**COMMENTS ON THE DRAFT SOUTH EAST QUEENSLAND WATER STRATEGY
July 2008**

Report compiled by S. Burgess. (Catchment officer)

Submitted to QWC/published: 31/07/08.

Figure E Projected infrastructure program: Climate resilient and surface supplies (medium series population growth and no allowance for climate change)

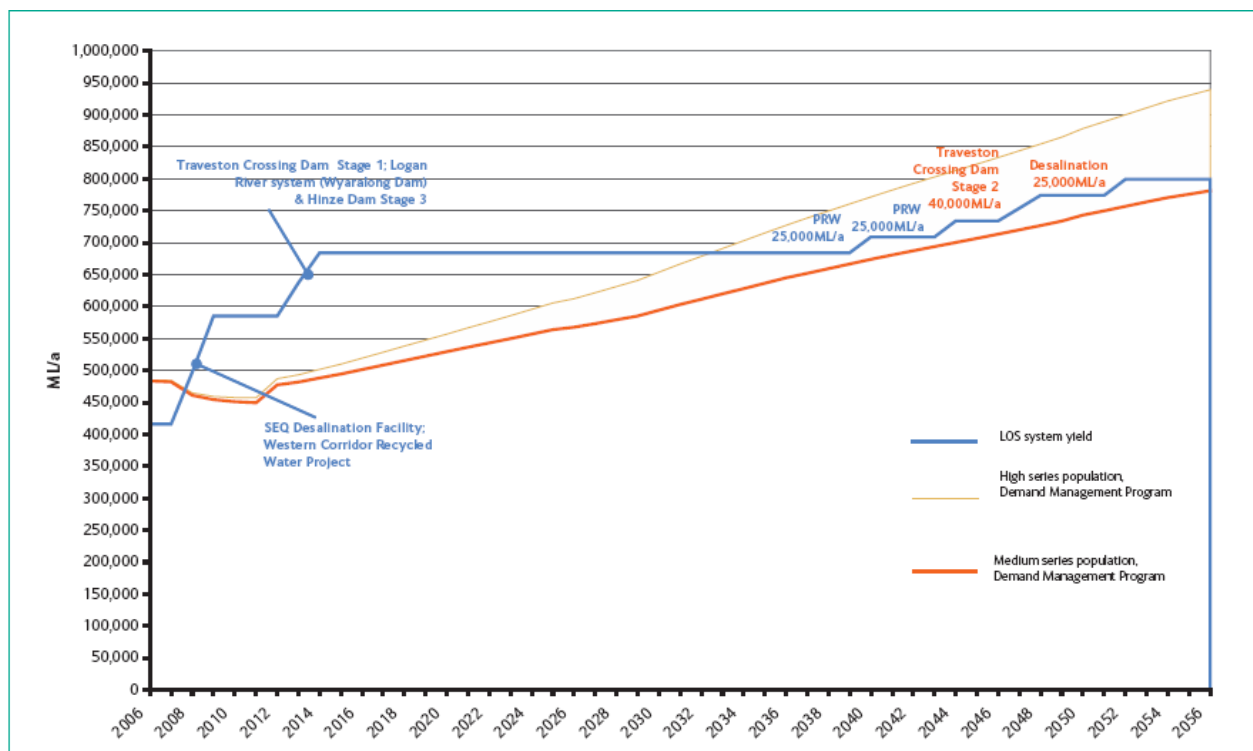
Another progressive aspect of the draft strategy, which is wholly endorsed by the MRCCC is the explicit readiness approach which holds the next anticipated piece of water supply technology in readiness for the appropriate supply/demand trigger. Closely matching the supply and demand curves in this way provides water security, and maximizes the economic efficiency of public investment in water infrastructure. This very enlightened response to uncertain future demand and supply situations is in stark contrast to the remarkable mismatch between projected supply and demand produced by the so called 'committed' infrastructure over the next quarter of a century. (See figure E, p21 of the draft strategy - reproduced below).

The information about the future demand/supply balance presented in the Strategy for 'non-drought' conditions confirms the major conclusion drawn from the [2007 ISF/Cardno study commissioned by the Mary Valley Council of Mayors](#); that once the Western Corridor recycling scheme and the Tuqun desalination plant come on line, yield from the proposed Traveston Crossing Dam would do nothing but provide a useless surplus for more than a quarter of a century. Under such circumstances, it is remarkable that alternatives to such a financially, socially and environmentally costly project are not investigated in the draft strategy.

The socially and economically irresponsible anomaly of investing billions of dollars of public money in water infrastructure for the purpose of producing a large water surplus decades ahead of the predicted demand is a major flaw in the Strategy as it stands.

Example of 'cut and paste' replanning, without a mid-stream dam on the Mary River and reduced interbasin transfer. One of the many possible scenarios not investigated in the draft strategy.

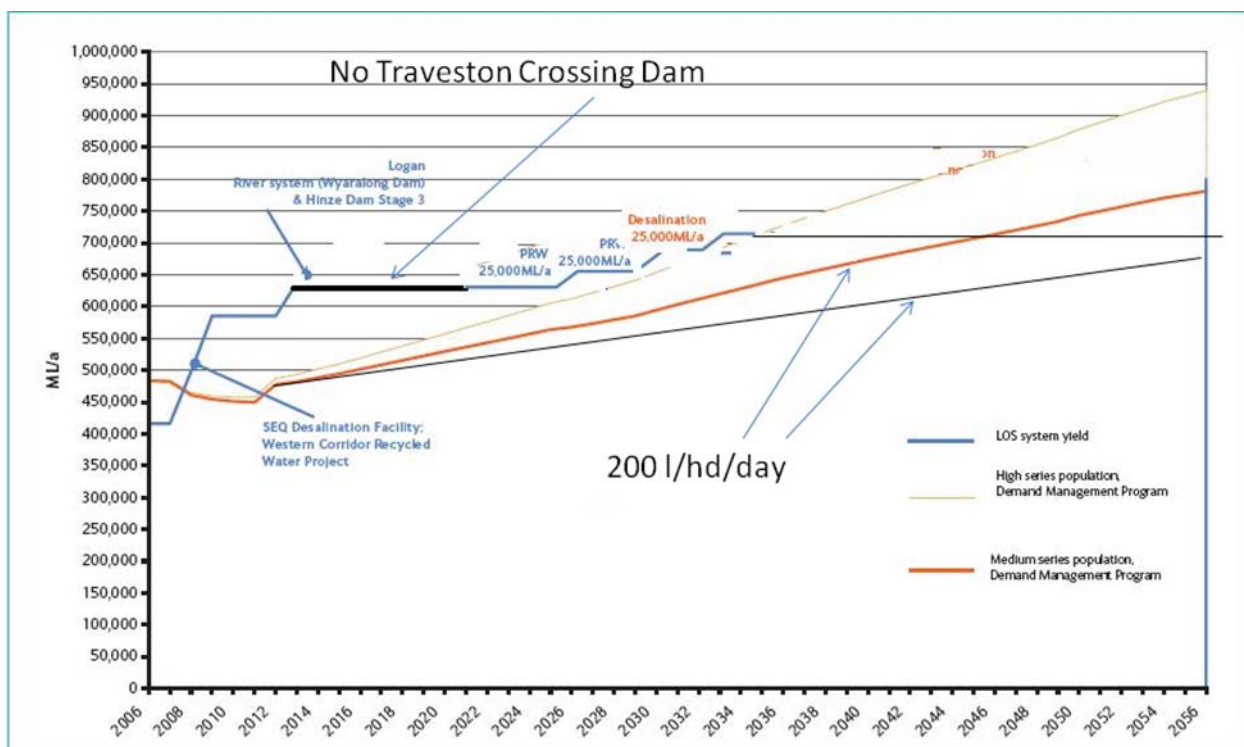
At a very simplistic level, it is possible to demonstrate an example of an alternative supply/demand scenario from figures in the draft strategy that does not involve the construction of the Traveston Crossing dam stage 1 or 2 and does not require additional interbasin water supply from a raised Borumba Dam. Such a simple option could still supply water security over the life of the Strategy, and represents a saving of billions of dollars, without the environmental risks posed by the proposed dam. This can be illustrated by simply 'cutting and pasting' components of the supply curve from the Strategy to bring forward options already in the Strategy, and allowing for a 15% reduction in the demand curves (commensurate with achieving 'target 200' rather than 'target 230' consumption behavior). This is only suggested as an example. It may be more effective to encourage effective Water Sensitive Urban Design (WSUD) in all new developments to achieve a similar flattening of the demand curve. The point made here is that no scenarios like this have been investigated in the Strategy.

This represents a major flaw in the current water planning process in SEQ, and may result in SEQ being burdened by a drastically sub-optimal water strategy for the next century and beyond.

Figure 2. Volume of water stored in Somerset/Wivenhoe system compared to Traveston.

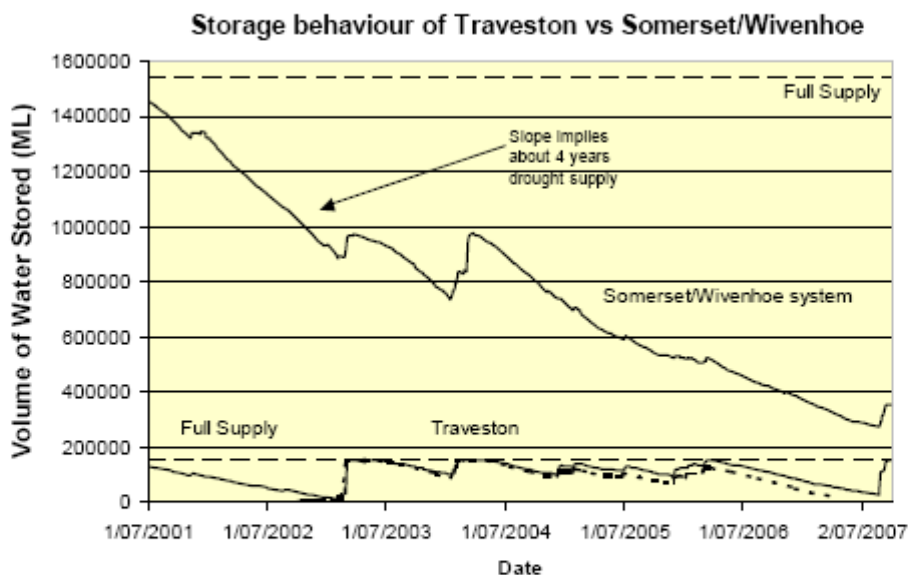
As shown in the figure below, these data imply that at the 'Level of Service' (LOS) yield of 70 GL/annum, the proposed dam at Traveston Crossing would only provide approximately 18 months of supply in a prolonged drought situation.

Annual flow at Traveston Crossing = 0.7 * Annual inflow of Somerset/Wivenhoe system
 R^2 (1895 - 2006) = 69%

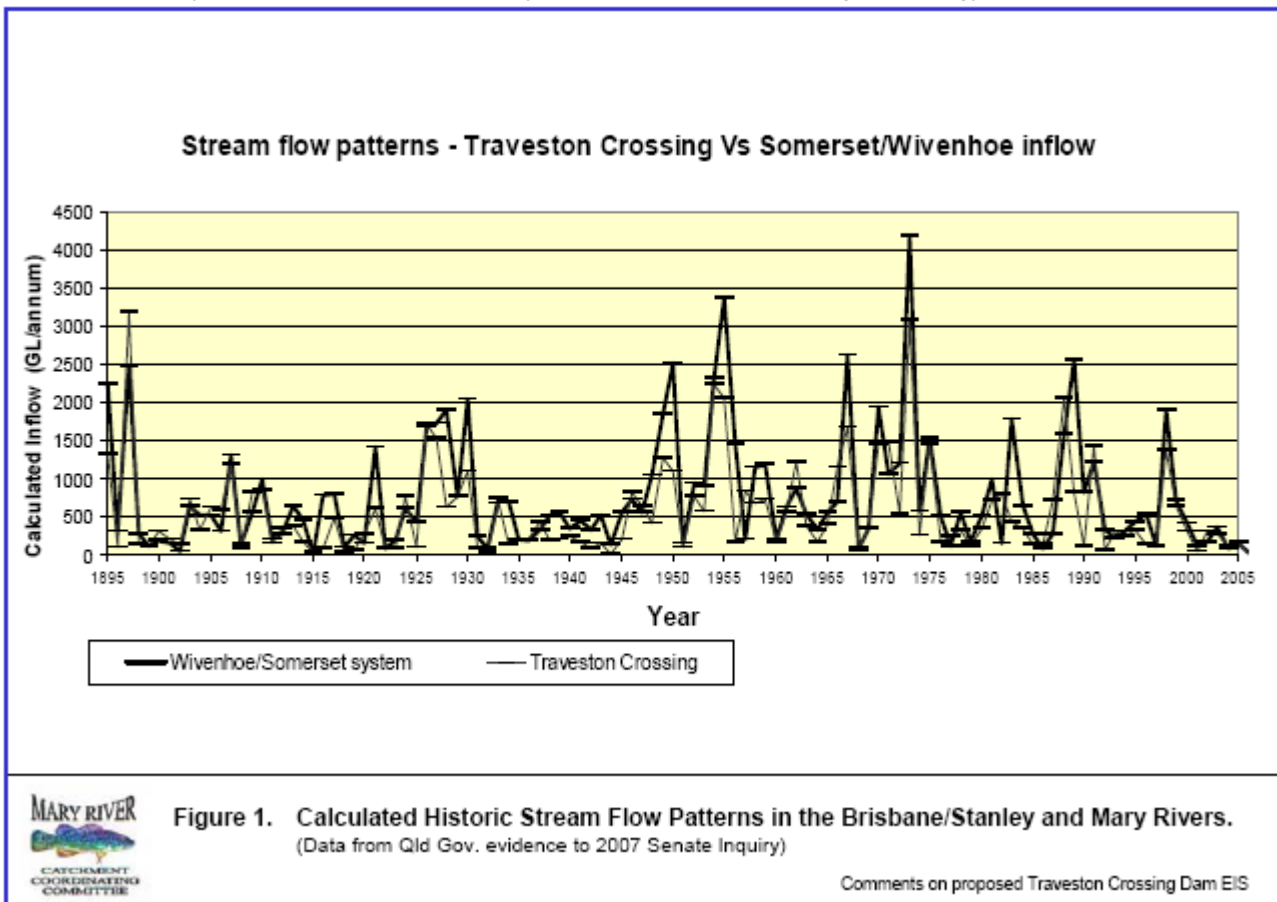
Another aspect of the drought behavior of the Mary Catchment that seems to be misrepresented in the draft strategy is the location of the Mary Catchment and the implication that it experiences a climatic regime that would somehow be able to provide water for SEQ at times when the rest of SEQ is in drought. This is simply not borne out by the geography of the catchment, nor by an analysis of streamflow data in comparison with the adjoining Somerset/Wivenhoe catchment.

The statistical linkage between the catchments is reflected in the high correlation between modeled annual inflows into the Somerset/Wivenhoe system and modeled flows at the Traveston Crossing damsite. This correlation can be calculated from data presented to the 2007 Senate Inquiry, and the analysis is presented below. In simple terms, annual flow at the Traveston Crossing site is about 70% of Wivenhoe/Somerset inflows for the same year. Therefore, a low-flow year in the major Somerset/Wivenhoe system is also a low-flow year at the Traveston Crossing site. It is important to remember that the existing Somerset/Wivenhoe system also has a very large drought reserve capacity (more than 4 years), while the proposed Traveston storage has a very low drought reserve capacity (about 18 months) at the specified LOS yields.

In conclusion, when the Somerset/Wivenhoe system is full (and interbasin contributions not required) so would be the proposed dam at Traveston Crossing. But, when the former is at low levels, a dam at Traveston Crossing will have already been low for a number of years; a non-existent drought strategy.

Comparison of ‘no climate change’ (left) and ‘climate change’ (right) water supply scenarios from the Strategy

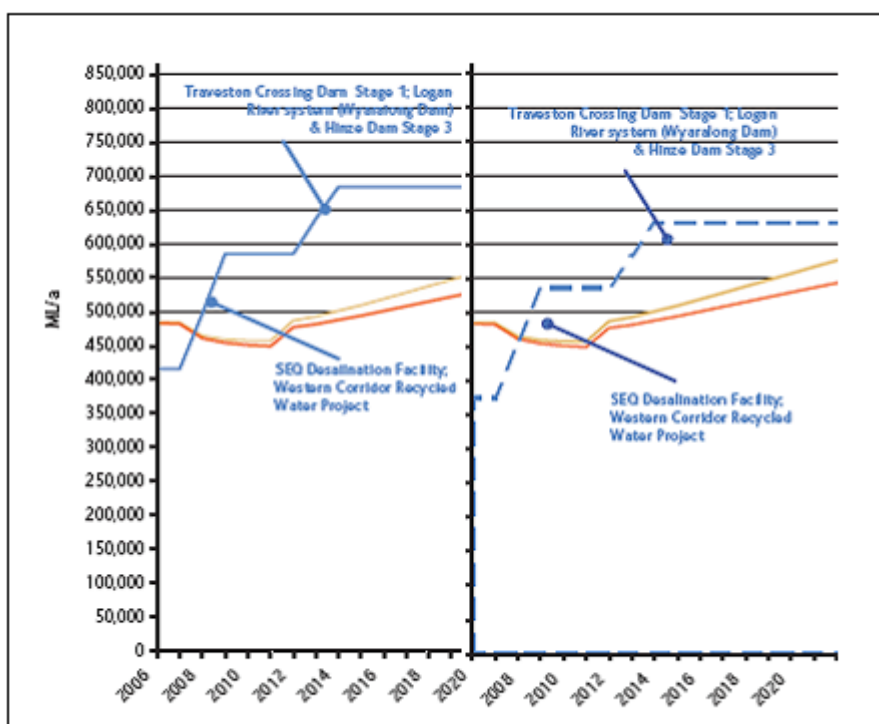
The figure below compares the non-climate change water supply scenario with the climate change supply scenario considered in the draft strategy, displayed side-by-side on the same scale. It is extraordinary that the supply increment from the ‘committed’ new surface water supplies is not reduced in the climate change scenario. Hopefully this is merely an unfortunate oversight, but it is a worrying symptom of unclear thinking in the ability of the Strategy to deal with the risk of climate change.

The relatively small allowance for reduced yield from surface water supplies in the face of climate change is at odds with general observations of the relationship between streamflow and rainfall. In a catchment like the Mary a small percentage decrease in annual rainfall is likely to result in a much greater percentage decrease in surface water flow. Preliminary estimates from MRCCC analysis on streamflow and rainfall in the catchment suggests that a 10% decrease in annual rainfall in the upper Mary Valley would be accompanied by about a 30% decrease in streamflow at Traveston Crossing. This finding is on a par with work done on other Australian catchments.

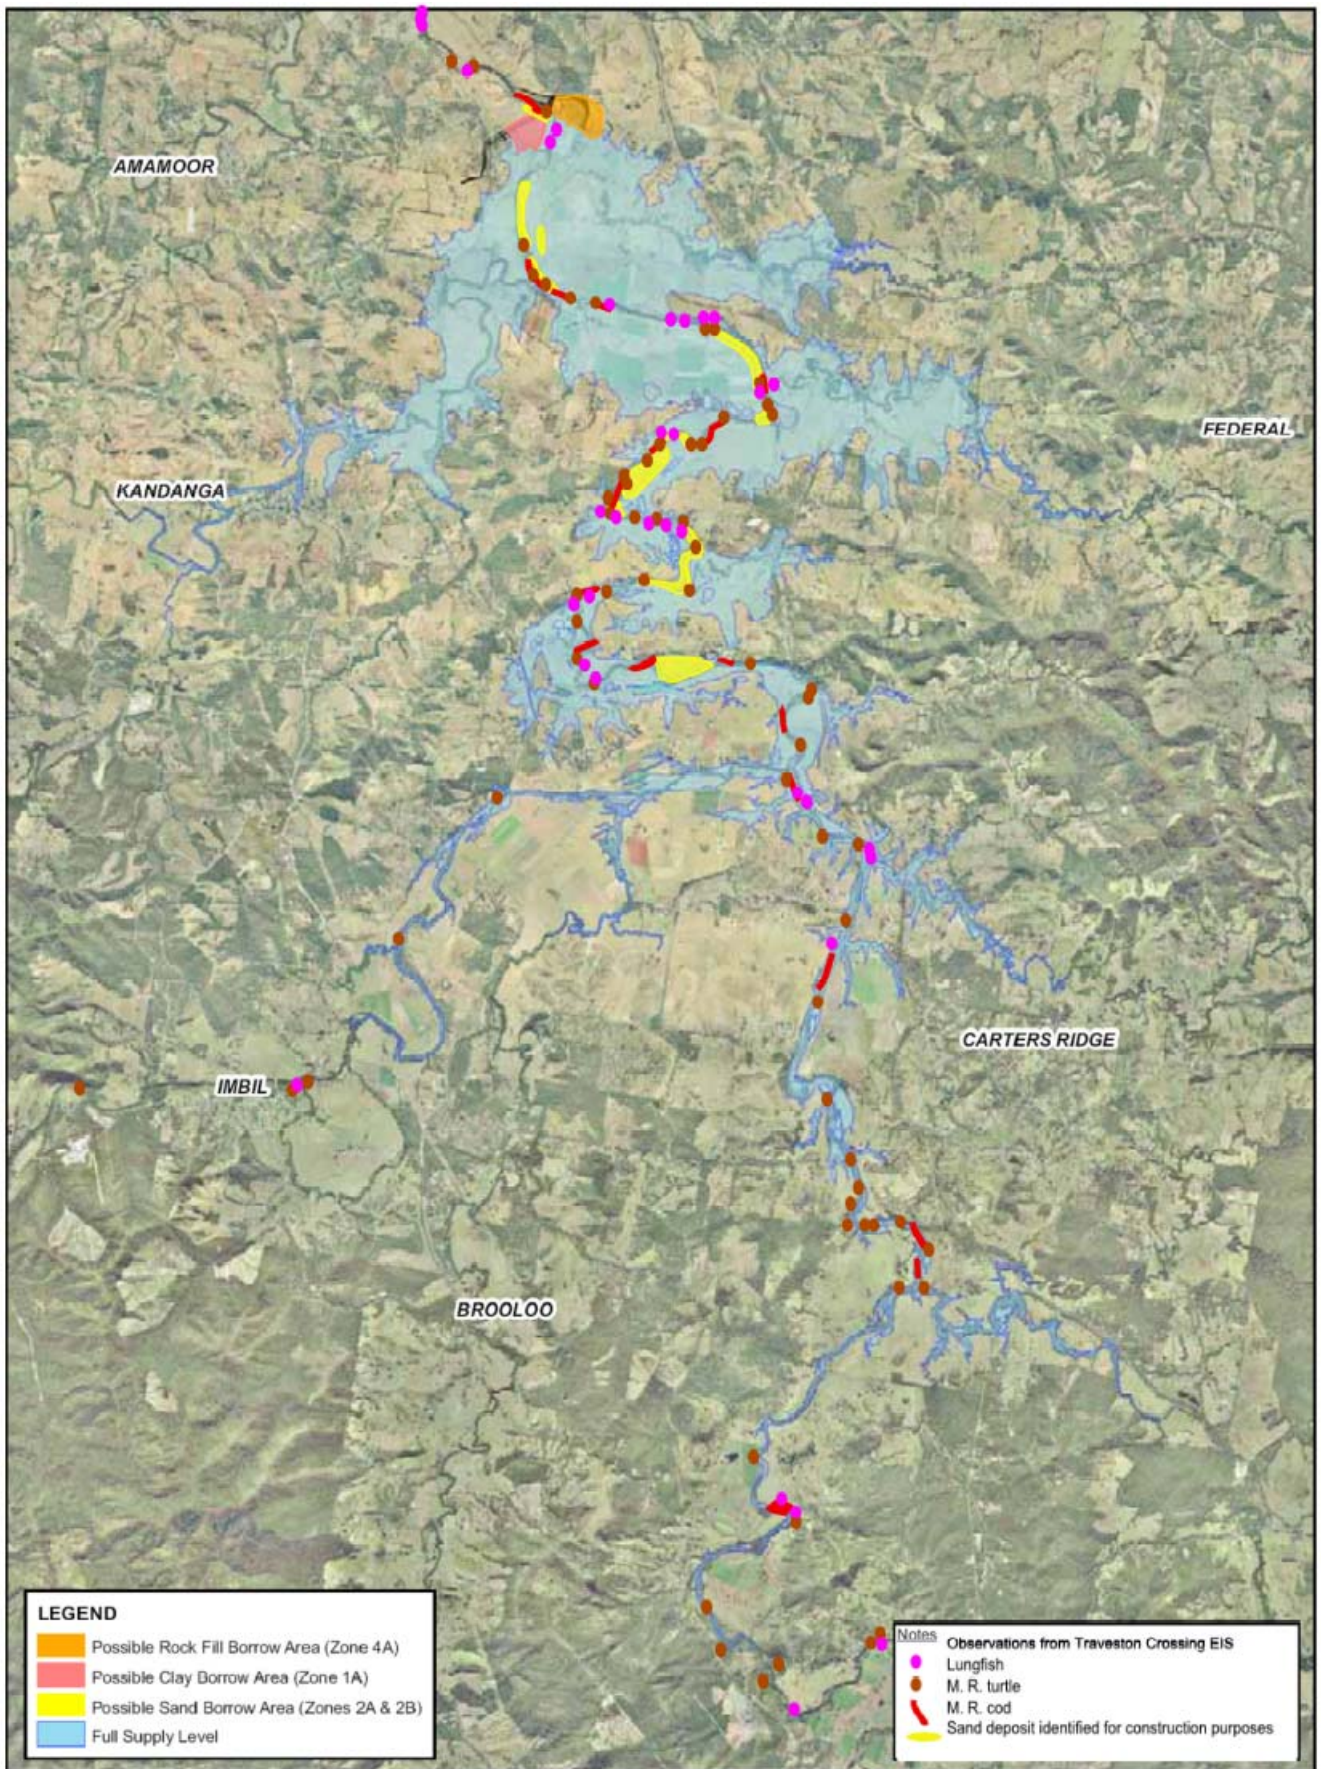
Later work has shown that the floodplain reaches of the main trunk of the river provide crucial in-stream habitat for a number of ecologically significant threatened species, particularly Mary River Turtle, Mary River Cod, Australian Lungfish and, in several crucial locations, Giant Barred Frog. This is evident in the survey data collected for the EIS for the proposed dam at Traveston Crossing, and is the reason why the MRCCC has nominated the [ecological communities of the pool, riffle and sand bar sequences of the Mary River floodplain](#) for listing under the EPBC Act. An example of the recorded distribution of these iconic species in the proposed infrastructure footprint is shown on the next page.

In light of the sheer number of Matters of National Environmental Significance that are adversely affected by the proposed dam and the associated pipeline, the MRCCC strongly believes that these projects are not ecologically sustainable. As yet, the proponents have not been able to clearly demonstrate the effectiveness of the measures proposed to mitigate or offset the adverse impacts that are expected to follow from these proposals.

It is premature to lock these projects into the water strategy before their impacts have been fully assessed and an appropriate decision has been made under the relevant state and federal laws.
